SAFETY ALERT

Trim Tab Reinforcement

SA-ASTM-CTSW-03

FLIGHT DESIGN USA SAFETY DIRECTIVE No.15

Fig B1 & B2: Reinforcement installed to the trim tab
(Tab shown bottom surface facing up)

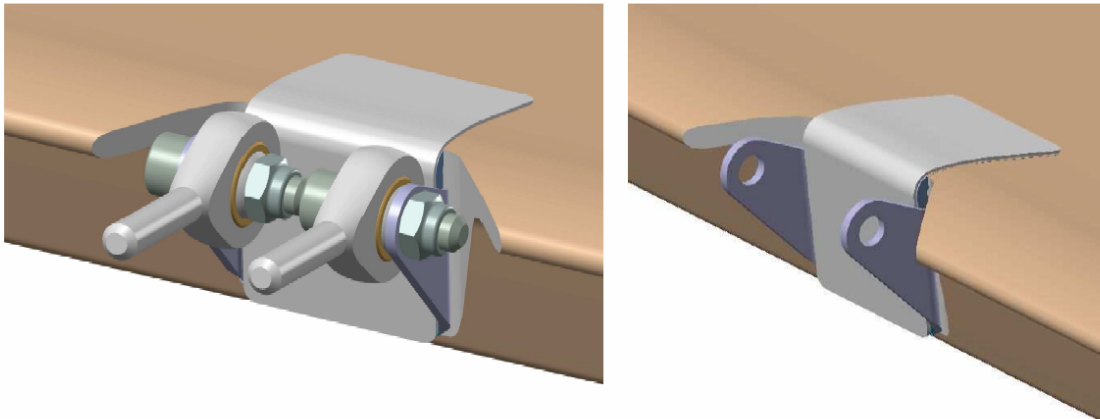
The reinforcement procedure consists of reinforcing the point at which the control horn is bonded to the trim tab by the addition of specifically designed part manufactured by Flight Design (WA 3011011). The part is glued (bonded) to the control rod bracket and the lower trim tab surface with resin and delivers a secondary load path for the trim tab control forces.

The modification can be done without removing the trim tab, and does not require painting. (Figs.B1 & B2)

The procedure shall be completed according to Flight Design document: 070625- Trim Tab Reinforcement Procedure that accompanies this Safety Directive, and supplemented by the Maintenance Manual.
